LS2085_88ARDBE

LS2085A/LS2088A Reference Design Board Errata

Rev. 3 — 28 May 2021

Errata

Figure 11. E-00015 workaround

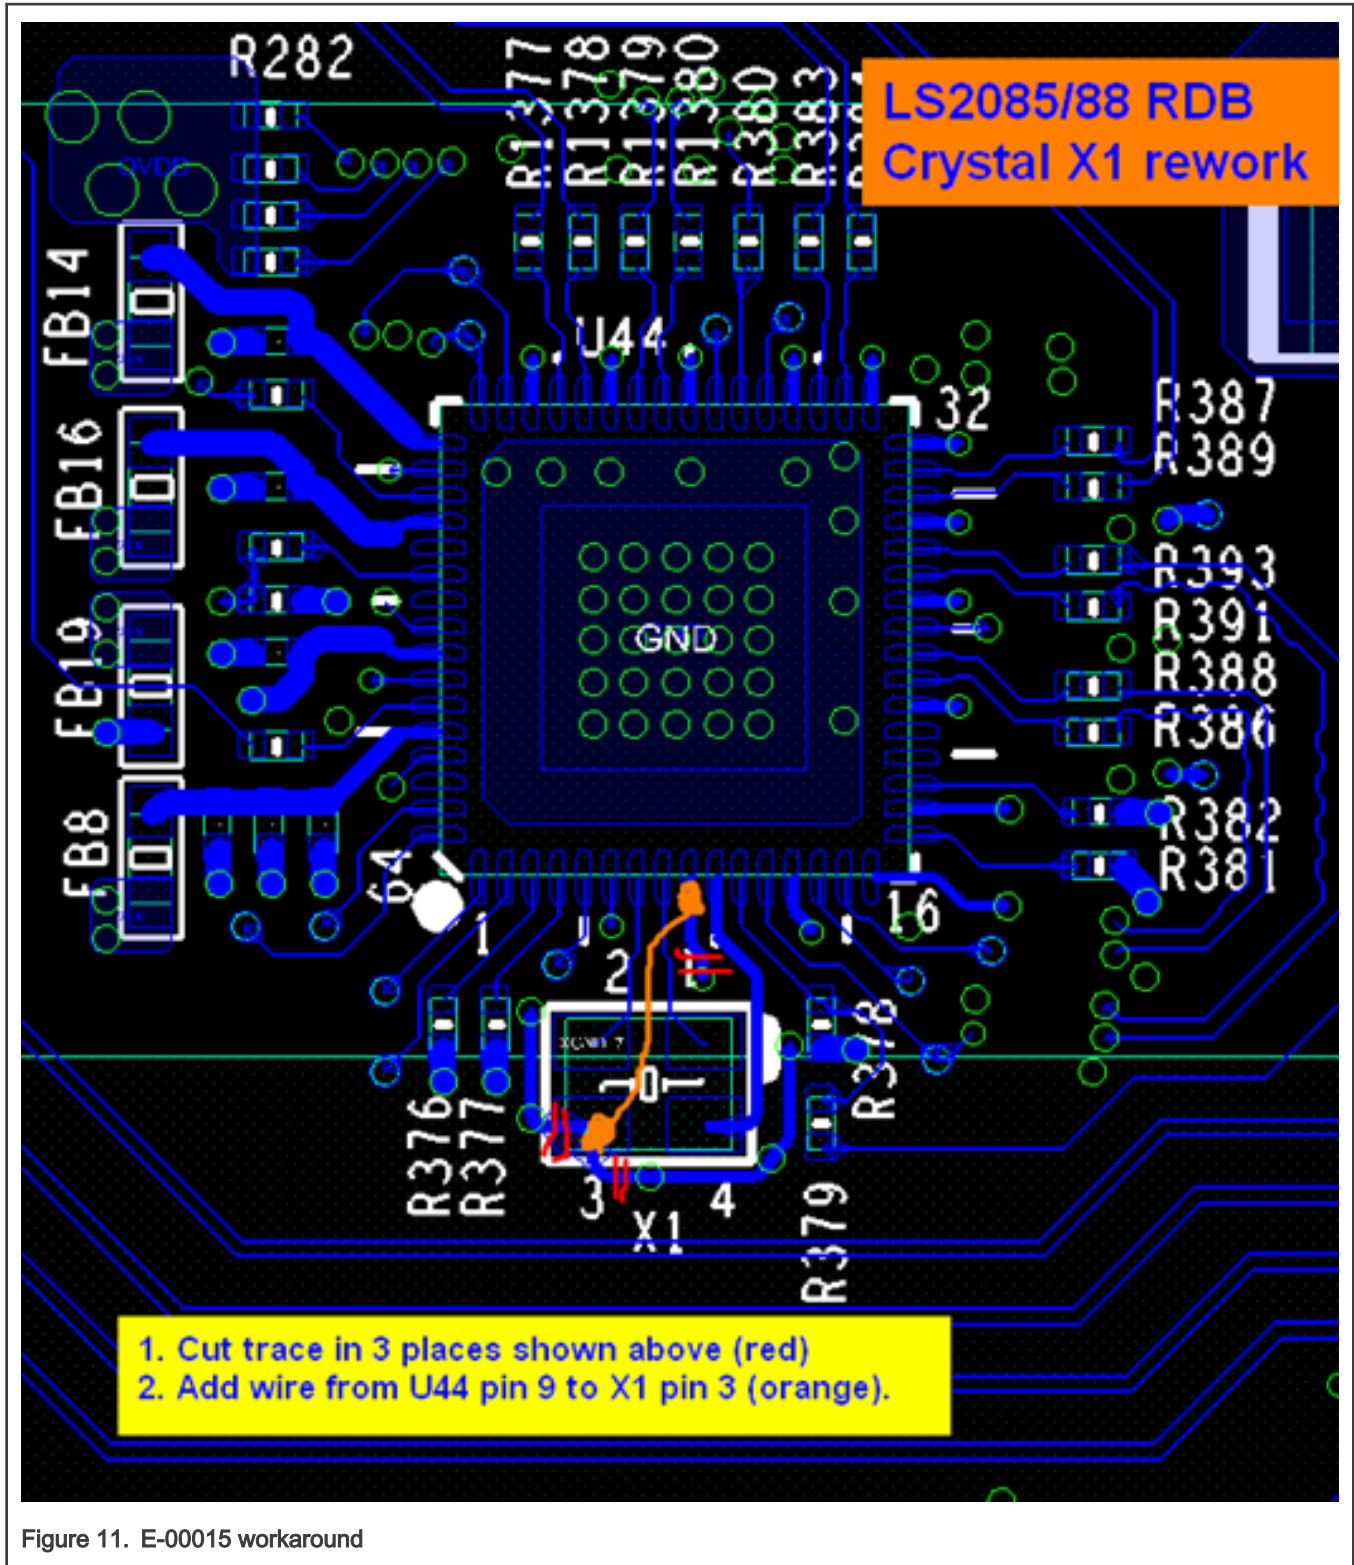
E-00015: Main clocking source frequency out of tolerance

Board layout issue has excessive capacitance on crystal X1 pin 3 (net XB_Si5341B). Due to excess capacitance, the frequency tolerance of all clock outputs from U44 is slightly out of specification (too slow at approx. -100 ppm).

Ethernet traffic may exhibit some bit errors on some boards.

Cut three traces as shown in the figure below and add a wire from U44 pin 9 to crystal X1 pin 3.

Rev. F and later boards have correct layout to remove excess capacitance. No other correction is required.

Figure 12. E-00016 workaround

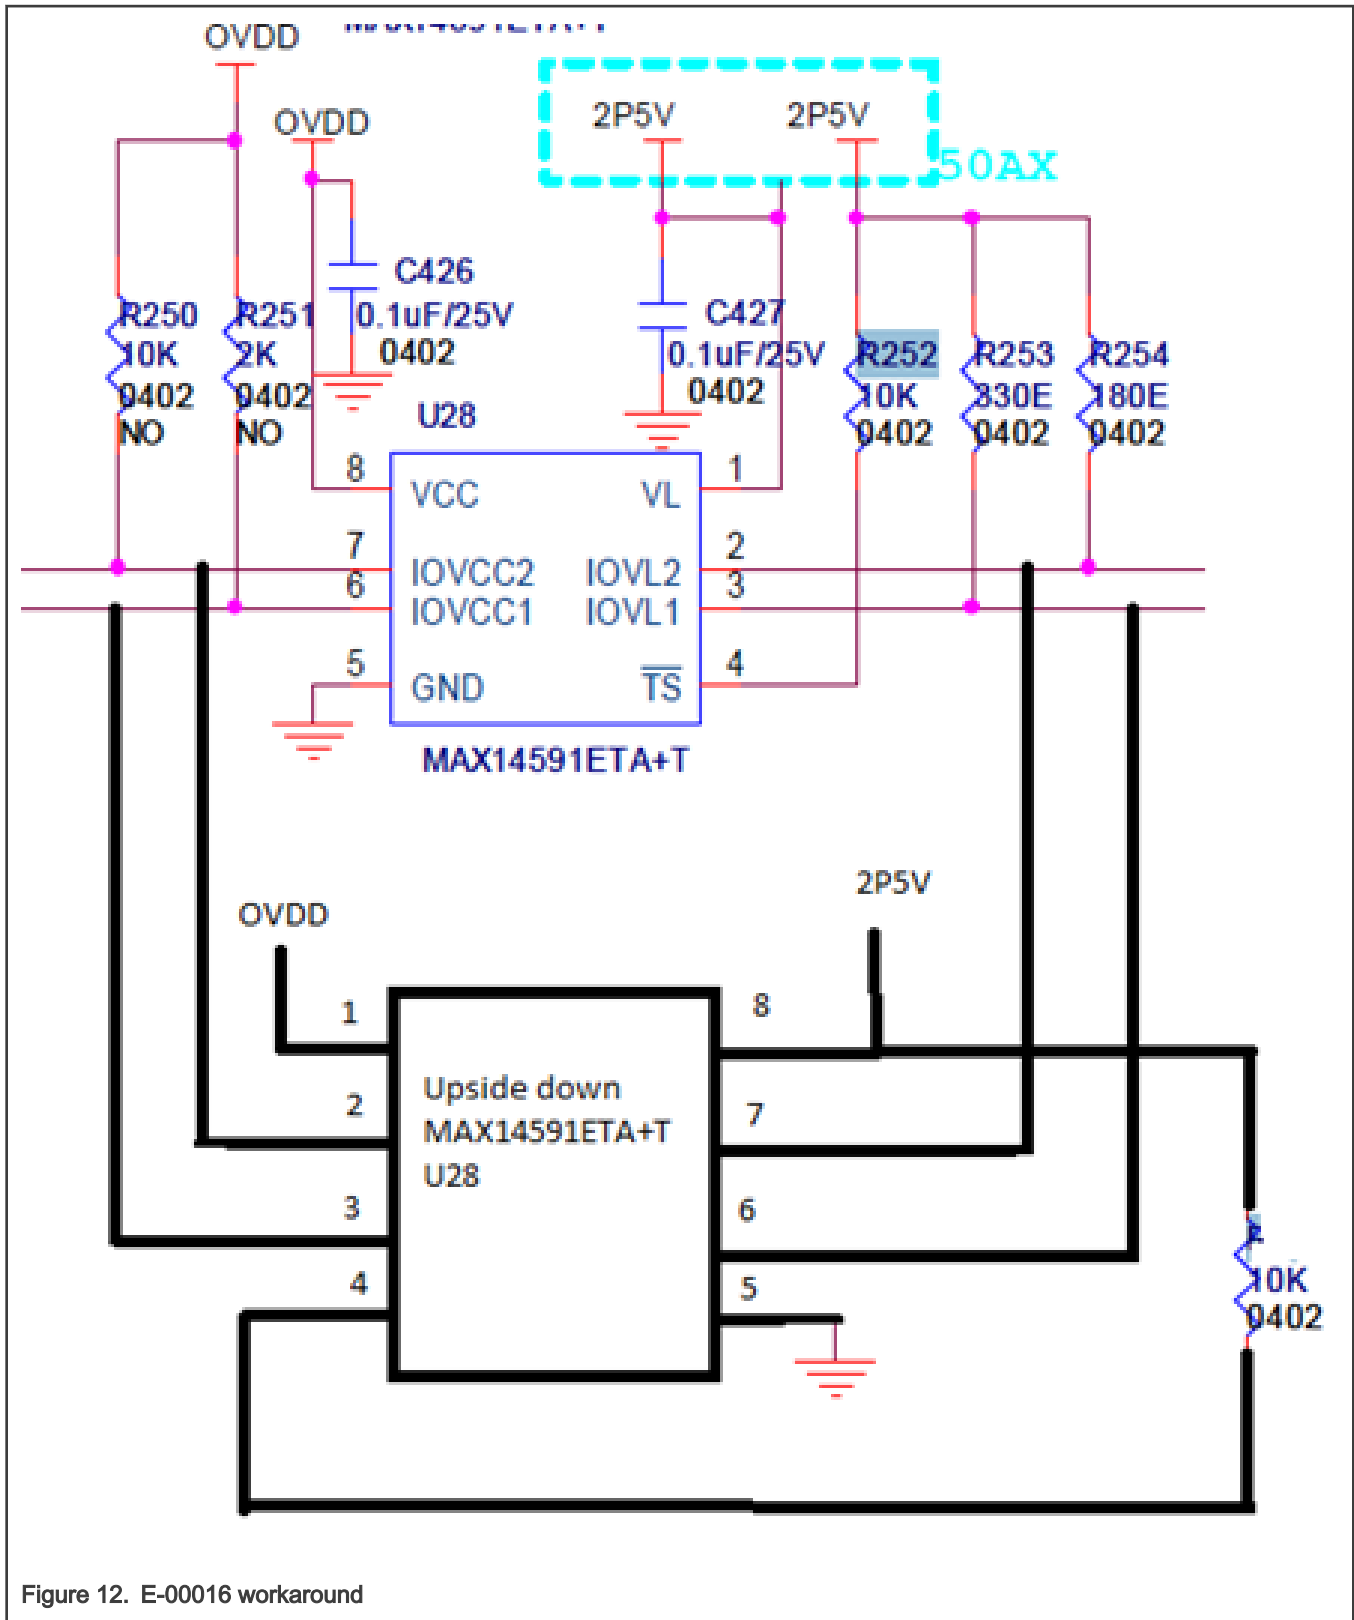
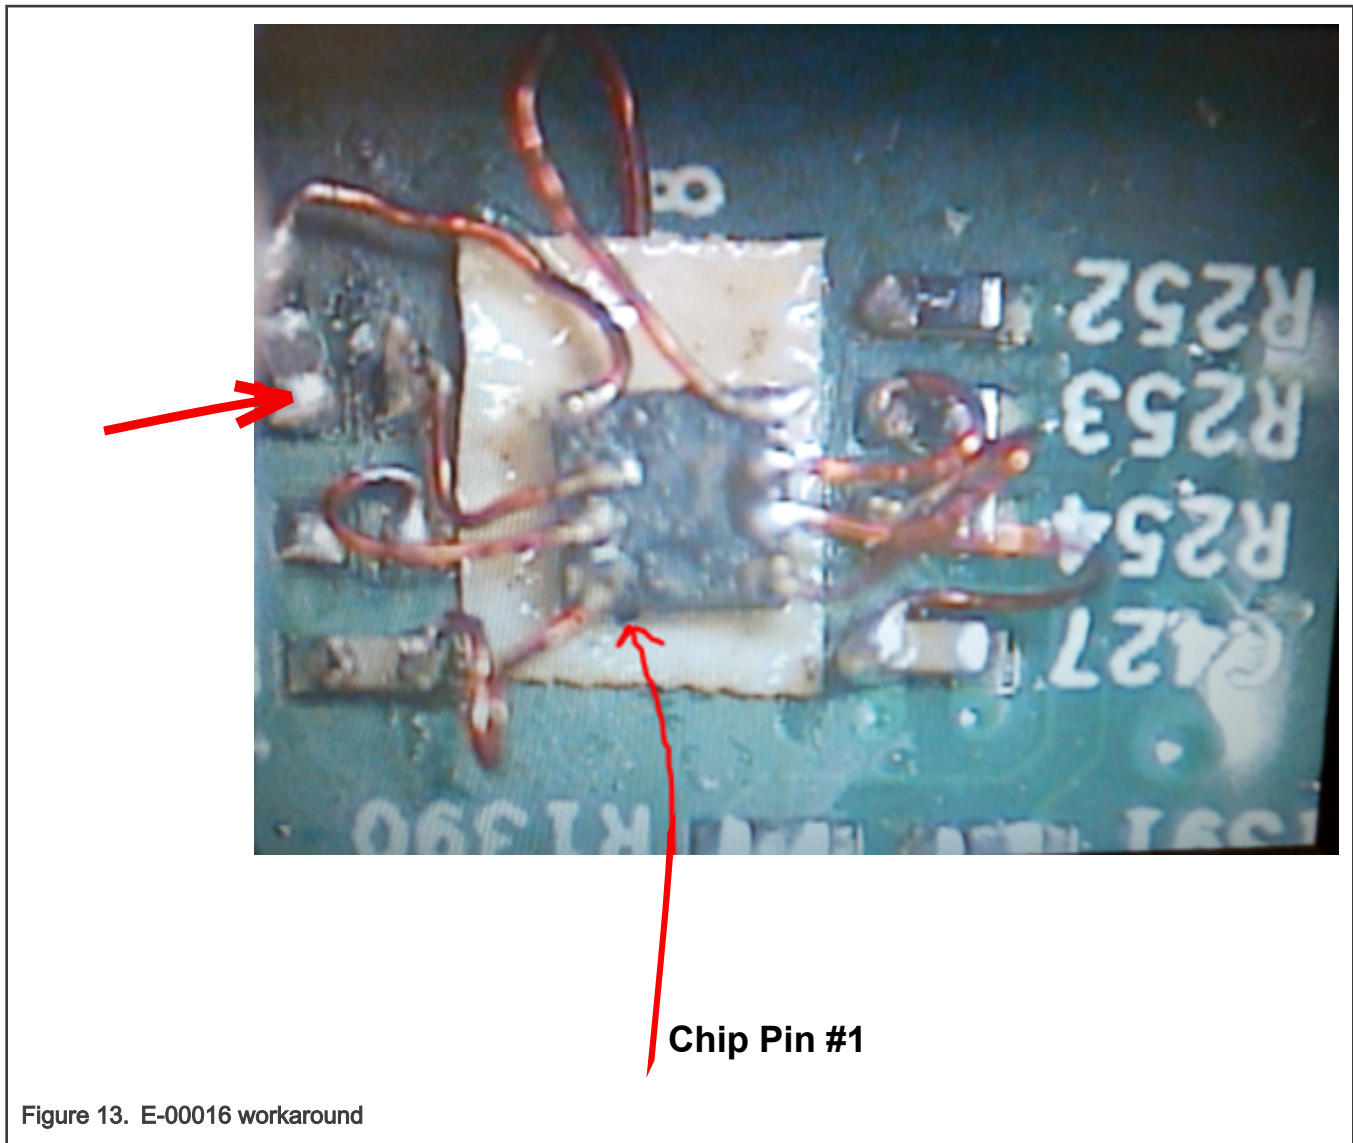
E-00016: Unable to access AQR405 through EMI2 bus (MDC/MDIO)

Rev. E boards only: The voltage signaling interface on the EMI2 (MDC/MDIO) bus has been changed from 1.2 V to 2.5 V on Rev. E boards. This change was requested by Aquantia for the AQR405 device. The change to 2.5 V levels requires flipping the voltage translator U28 backwards, which is not done in Rev. E board. The U28 voltage translator does not work with the new 2.5 V levels unless it is reversed.

Software cannot access and configure the AQR405 (10GBase-T) PHY over the EMI2 bus, unless board is reworked to reverse U28.

Remove U28 from the PCB pads and re-wire as described below:

Remove U28 and flip chip and re-wire the pins as shown in the figures below. This is required because VL must be equal to or lower than VCC.

Adding a 10K ohm resistor to pin 4 makes the connection simple. The white material under the chip is double-sided tape to keep the chip in place.

Rev. F and later boards have U28 wired as shown in the diagram above. No other correction is required.
